## **SUNSET CREEK SUBDIVISION**

Engineering Comments: FINAL PLAT COMMENTS (should be addressed prior to submitting the FINAL PLAT for review and/or signature by the City Engineer):

APPLICATION NUMBER 11 DATE September 7, 2017

# DETAIL SITE PLAN

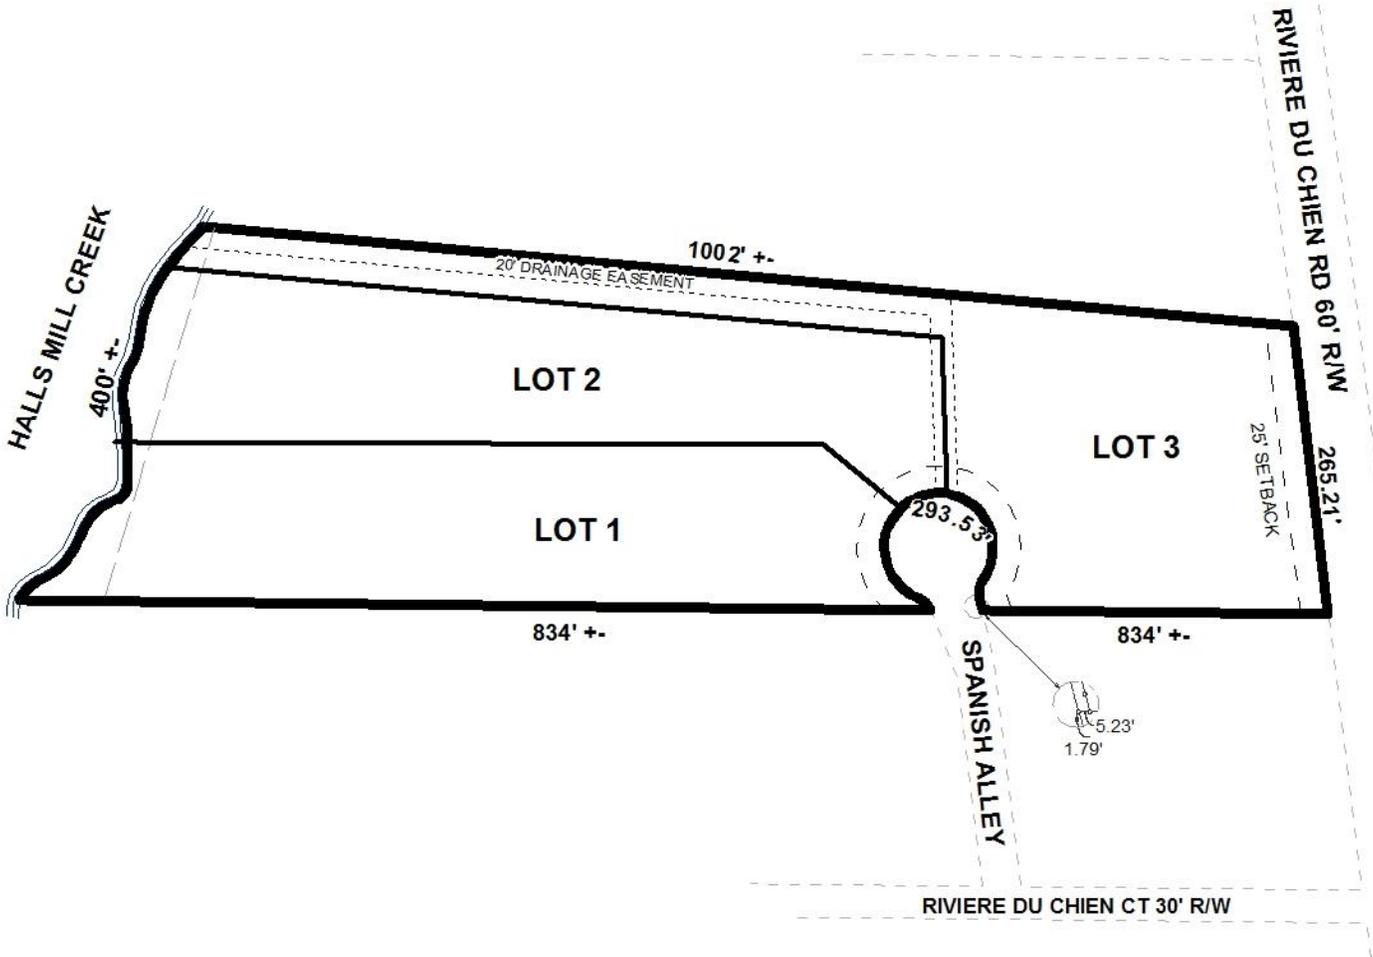
The lots are irregularly shaped with frontage along Spanish Alley, a minor closed-end street without curb and gutter requiring a 50' right-of-way width and 120' turnaround right-of-way

diameter. Lot 3 also has frontage on Riviere Du Chien Road, a minor street without curb and gutter requiring a 60' right-of-way width. Sufficient right-of-way is illustrated along Riviere Du Chien Road, but not along Spanish Alley; however, it should be noted that previous subdivision of the site only required an additional 5' of dedication along Spanish Alley. As such, no additional dedication should be required.

It should be noted that the widths of frontages along Lots 1 and 3 are large enough to be potentially re-subdivided and, in accordance with Section V.D.3. of the Subdivision Regulations are not exclusive of unusable land thus contributing to maximum depths greater than 3.5 times the widths of the lots at their potential building lines. A similar width-to-depth ratio is illustrated for proposed Lot 2, though under different circumstances. It should also be noted that the design of proposed Lot 3 may also be regarded as a "panhandle" lot, which is generally discouraged by Section V.D.1. of the Subdivision Regulations; the exceptions being the approval of lots located where varied and irregularly-shaped lot designs are common, and the informality of design is consistent with other lots in the vicinity. Planning Commission approval of various irregularly shaped lots within the immediate vicinity of the subject site, along with previous subdivision approval of the site may facilitate approval of the request at hand; however, waivers of Sections V.D.1. and V.D.3. should be required, if approved. Also, if approved, a note should be required on the Final Plat stating further re-subdivision of the lots will not be allowed until additional public street frontage is provided.

Irrespective of their width-to-depth ratios and irregular designs, the proposed lots do exceed the minimum size requirement of the Subdivision Regulations for lots served by public water and sanitary sewer, and are appropriately labeled in square feet and acres on the preliminary plat. This information should be retained on the Final Plat, if approved, adjusted for any required dedication(s); or, a table providing the same information may suffice.

The 25' minimum building setback is illustrated on the preliminary plat along all street frontages. This information should also be retained on the Final Plat, if approved, adjusted for any required dedication(s).

With regards to access management, a note should be placed on the Final Plat stating each lot is limited to one curb cut each to Spanish Alley, and Lot 3 is limited to one curb cut to Riviere Du Chien Road, with any changes in their sizes, locations or designs to be approved by Traffic Engineering and conform to AASHTO standards.

A 20' drainage easement is illustrated between proposed Lots 2 and 3, and along the Western portion of proposed Lot 3. As such, a note should be required on the Final Plat stating no structures will be constructed in any easement.

Based on the preceding, and with a waiver of Sections V.D.1. and V.D.3. of the Subdivision Regulations, the plat is recommended for Tentative Approval subject to the following conditions:

- 1) retention of the lot sizes in square feet and acres on the Final Plat, or the provision of a table on the Final Plat providing the same information;

- 2) retention of the 25' minimum building setback line along all frontages;
- 3) placement of a note on the Final Plat stating each lot is limited to one curb cut to Spanish Alley, and Lot 3 is limited to one curb cut to Riviere Du Chien Road, with any changes in their sizes, locations or designs to be approved by Traffic Engineering and conform to AASHTO standards;

- 4) placement of a note on the Final Plat stating no structures will be constructed in any easement;
- 5) compliance with Engineering comments: (FINAL PLAT COMMENTS (should be addressed prior to submitting the FINAL PLAT for review and/or signature by the City Engineer): A) Provide all of the required information on the SUBDIVISION PLAT (i.e. signature blocks, signatures, certification statements, written legal description, required notes, legend, scale, bearings and distances) that is required by the current Alabama State Board of Licensure for Professional Engineers and Land Surveyors. B) Add a note to the plat stating that all easements shall remain in effect until vacated through the proper process. C) National Wetlands Inventory (NWI) mapping, as shown on City of Mobile GIS information, indicates that there is potential for wetlands within the property or properties shown on this plat. Show and label the delineated wetlands, or provide a note that the wetlands shown on this plat are scaled from the NWI data and have not been delineated. D) Provide a note that a 25' riparian buffer may be required, during development, along the edge of anything considered by ADEM to be a water of the state. E) Show and label all flood zones. F) Show and label the MFFE (Minimum Finished Floor Elevation) on each lot that contains an AE, V, or X (shaded) flood zone designation. G) Provide and label the monument set or found at each subdivision corner. H) Provide the Surveyor's, Owner's (notarized), Planning Commission, and Traffic Engineering signatures. I) Add a note to the SUBDIVISION PLAT stating that a Land Disturbance permit will be required for any land disturbing activity in accordance with Mobile City Code, Chapter 17, Storm Water Management and Flood Control); the City of Mobile, Alabama Flood Plain Management Plan (1984); and, the Rules For Erosion and Sedimentation Control and Storm Water Runoff Control. J) Add a note to the Plat stating that the approval of all applicable federal, state, and local agencies (including all storm water runoff, wetland and floodplain requirements) will be required prior to the issuance of a Land Disturbance permit. K) Add a note that sidewalk is required to be constructed, and/or repaired, along the frontage of each lot, or parcel, at time of new development or construction, unless a sidewalk waiver is approved. L) Add a note to the plat stating that all easements shall remain in effect until properly vacated through the City of Mobile Vacation process. M) Provide a copy of the FINAL SUBDIVISION PLAT to the Engineering Dept. for review. No signatures are required on this drawing. N) After addressing all of the FINAL SUBDIVISION PLAT review comments by the Engineering Dept. provide the ORIGINAL (with all other signatures) and one (1) copy (signatures not required) of the revised Final Plat to the Engineering Department.);
